CITY OF MOUNTAIN VIEW

June 30, 2010

COMMENTS ON THE PRELIMINARY ALTERNATIVES ANALYSIS REPORT

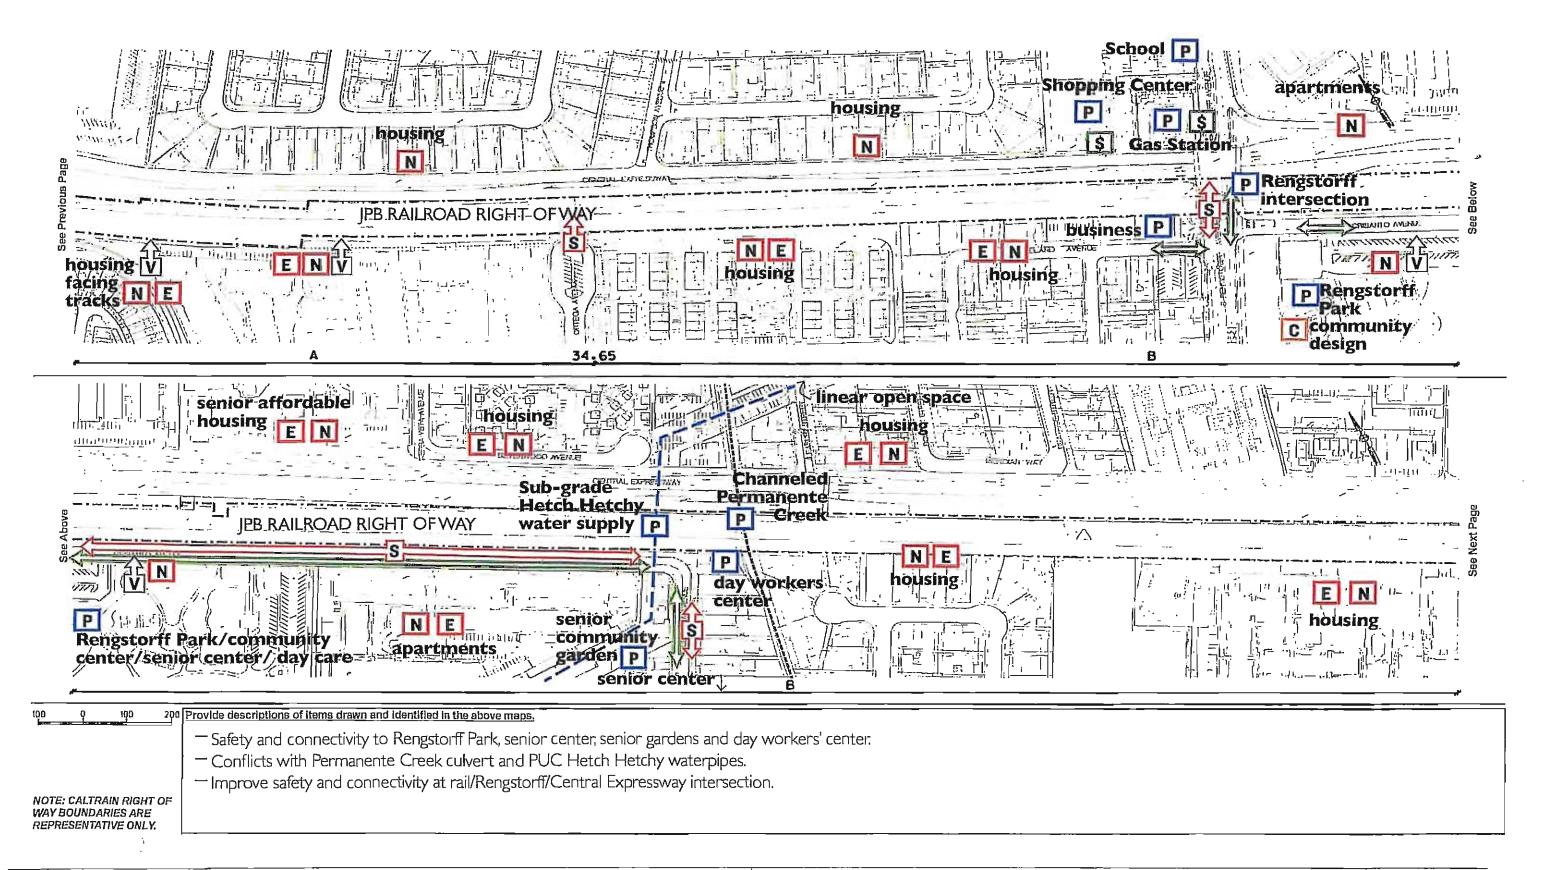
E: Minority businesses. Minimize impact.

S at Rengstorff: Improve safety for crossings as crossing is used by nearby schools and businesses.

Maintain cross connectivity at Rengstorff.

Provide east side access to the San Antonio platform.

- Maintain safety, station accessibility & connectivity to existing performing arts & future development of San Antonio & shopping center, existing neighbors along Showers Drive & Central Expressway.

- Maintain pedestrian/bicycle access tunnel at San Antonio Station. An extension of the pedestrian/bicycle underpass under Central Expressway to connect to new housing and neighborhood is planned.

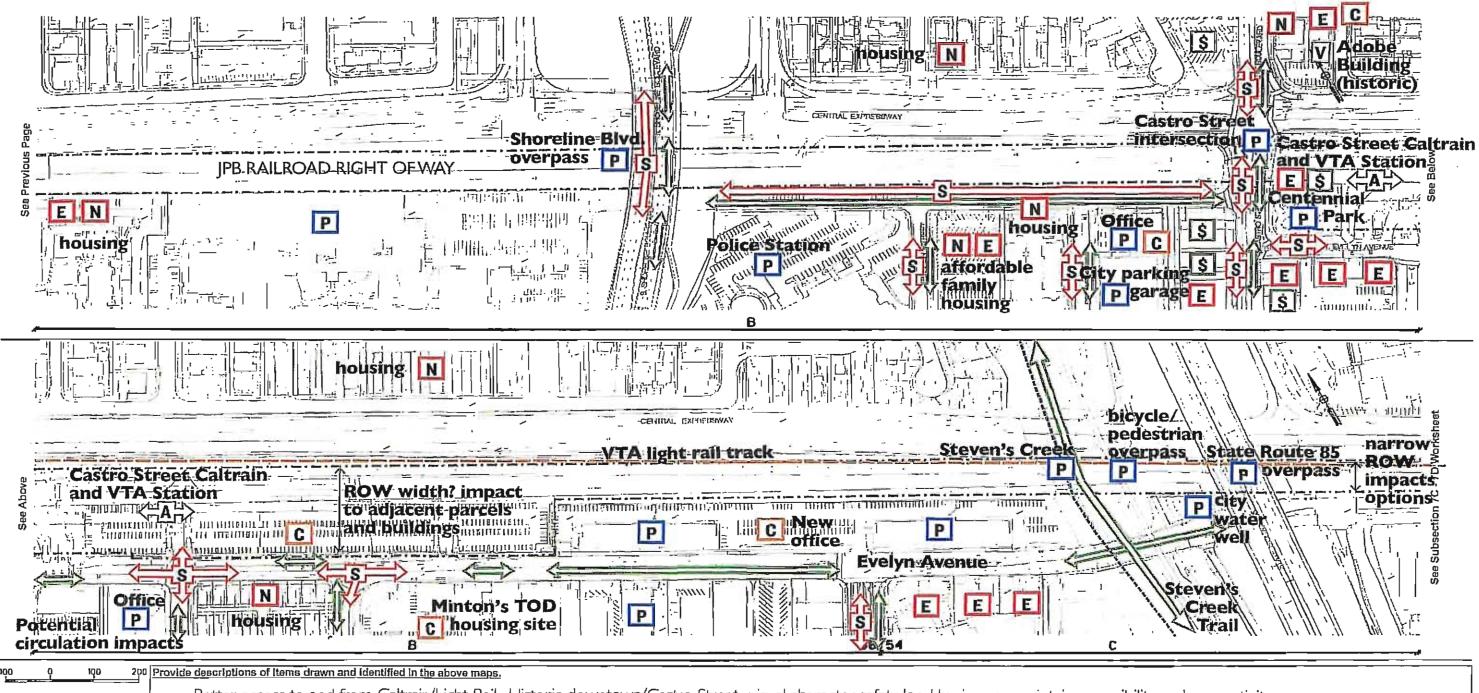
- Better access to and from Caltrain/Light Rail. Historic downtown/Castro Street- visual character, safety, local businesses, maintain accessibility and connectivity.

- Community has a Downtown Precise Plan and an Evelyn Ave. Corridor Precise Plan for this area.

- Major physical impacts to streets, roads and adjacent properties. Major visual impacts, especially from Castro Street. Major connectivity impacts - station area as well as city circulation.

- Major economic vitality impacts, potentially to adjacent properties.

— Maintain the amount of existing parking at Castro Station, opportunity for parking structure.

CASTRO ST. TRENCH ALTERNATIVE

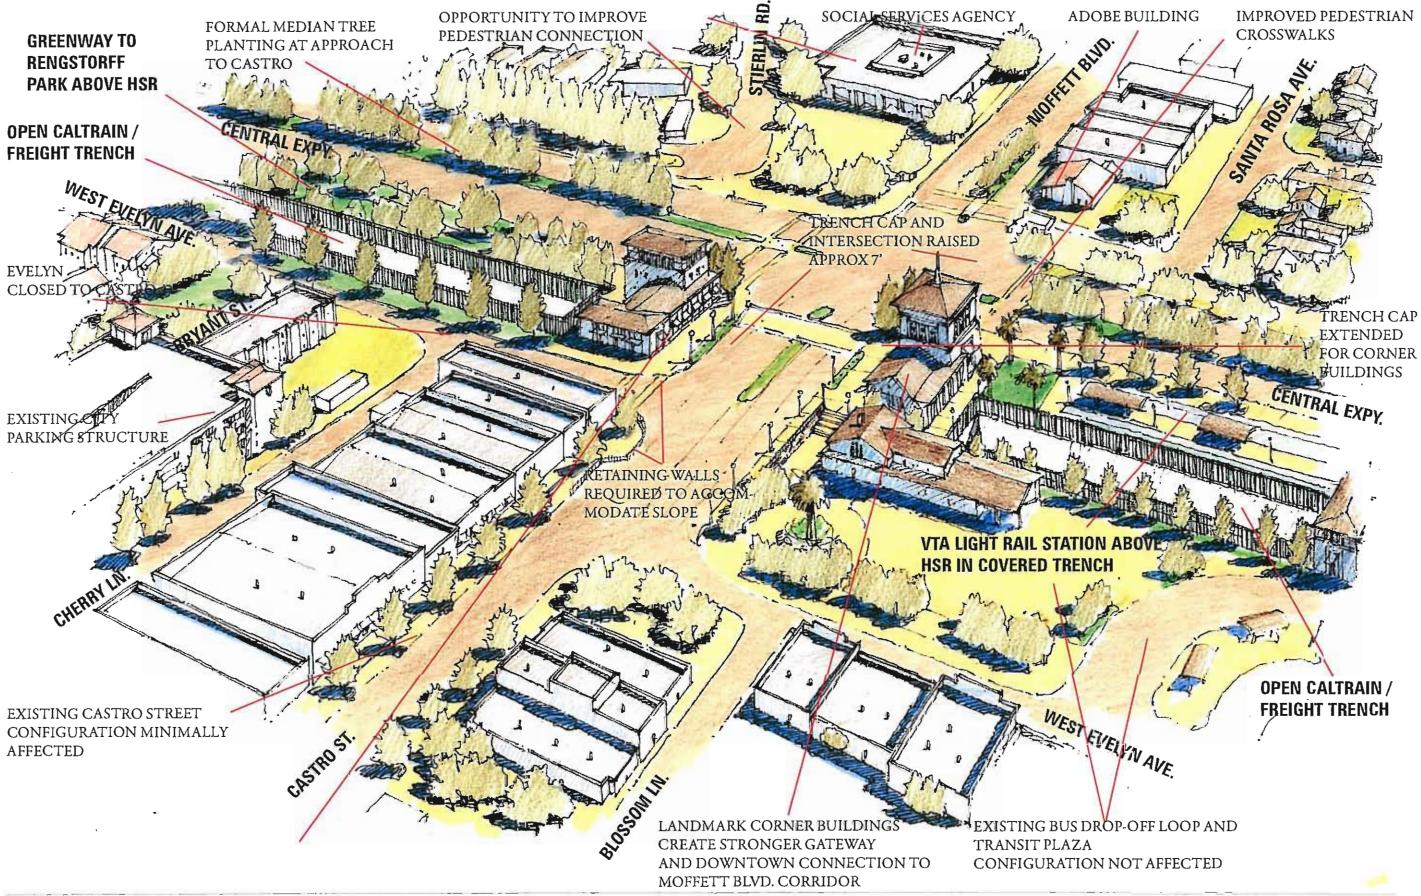
8. Enclosed with this letter are renderings prepared for the City of a partially covered trench alternative at Castro Street and at Rengstorff Avenue. The rendering shows the HSR tracks covered to provide a linear greenway between Castro Street/downtown and at Rengstorff Avenue. This greenway could provide an off-street, alternative transportation route between downtown and the Downtown Transit Center on the south and one of the City's community parks, the Community Center, the Senior Center and one of the City's most densely populated neighborhoods on the north. The City would like to explore this and other ideas with the Authority to provide community benefits along with the HSR project.
